### **VILLAGE BOARD AGENDA Wednesday, July 2, 2025 at 7:00 PM**

To: Village of Mount Horeb Plan Commission  
From: Village Planner: Ben Rohr, AICP  
Date: May 28, 2025  
Re: Proposed Amendment to the Specific Implementation Plan (SIP) and Design Review for a Proposed 3-Story Mixed-Use Building at 1881 Springdale Street for MMI, LLC.

## ELEVATIONS

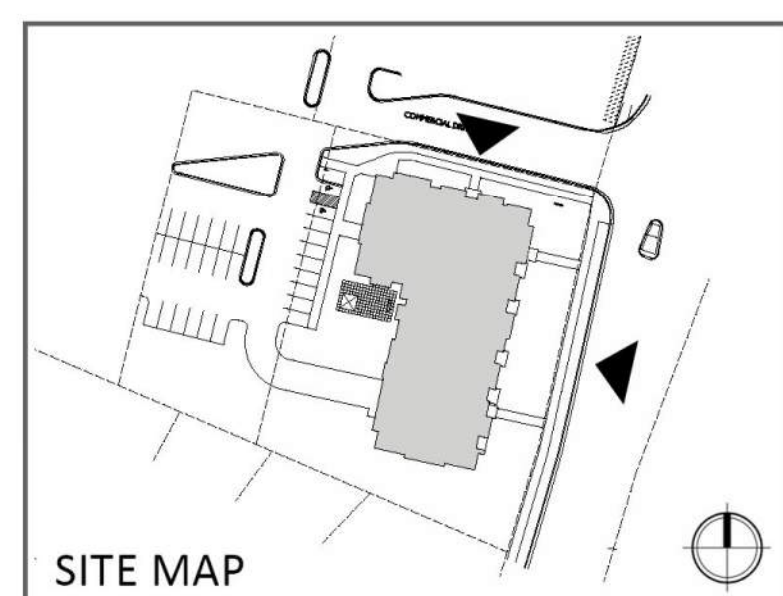
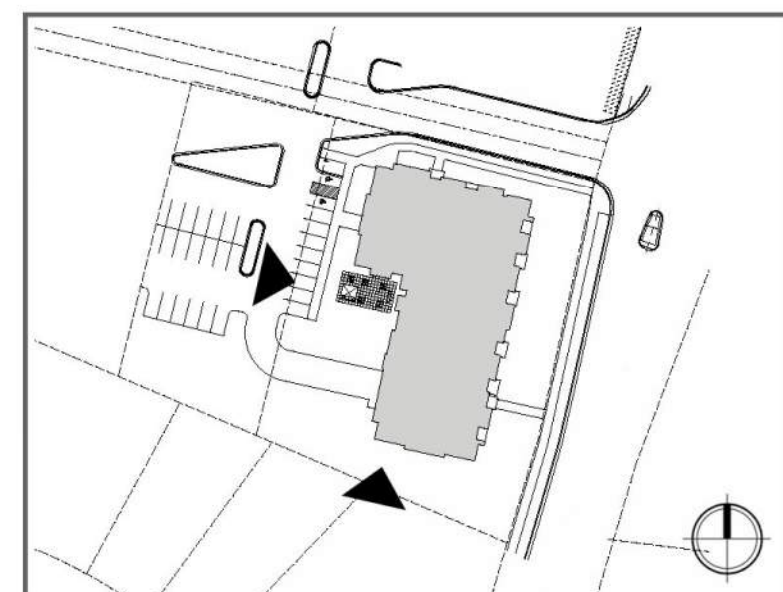
- The north and east elevations have retained the masonry stone base along each façade like the previous plan set, but the western elevation has replaced the masonry stone base with split face block. Additionally, the southern elevation no longer includes any hard durable surface around the base of the structure. No exterior color changes are proposed.

- Ventilation wall packs have been added to the exterior of each unit on the east and west facades, which were not previously proposed to be visible. Each is proposed to be flush with the façade, match the exterior building color, and blend in as much as possible.

- a. Exterior materials for multi-family, office, or commercial buildings may not include metal wall panels, concrete panels, plain concrete block, asphalt, or spandrel window panels, unless an exception is granted through the conditional use process.
  - This requirement is met. Proposed building materials include lap siding, composite trims, aluminum balconies, stone base, and split block base on the facades. To note, the building facades have slightly changed from the 2024 plan set as described on page 1.
- b. Hard and durable materials including decorative block, brick or stone, shall be required on all exterior portions of the structure within 40 inches of the adjacent grade.
  - This requirement is not met on the southern façade. The proposed elevation no longer includes a stone base on this portion of the façade. Additionally, on the western façade, the

stone base is proposed to be replaced with split block face. I recommend the Plan Commission waive this requirement.

- This requirement is not met with the proposed elevations in respect to the new ventilation wall packs proposed on each façade. However, each is proposed to be flush with the façade, match the material colors, and blend in as much as possible. I recommend that the Plan Commission waive this requirement.

3. Design Review as submitted to the Village, including waivers from the Design Review requirements approved by the Plan Commission, including:
  - a. 8.b. for not including hard durable materials along the base of the southern façade and allowing split block along the base of the western facade, as depicted.

- b. 13.a. for allowing ventilation wall packs on each façade, as depicted.
4. Village staff review and approval of the following that meets all Design Review requirements. If any waivers are requested by the applicant from the Design Review requirements, the proposed plans must be reviewed and approved by the Plan Commission.
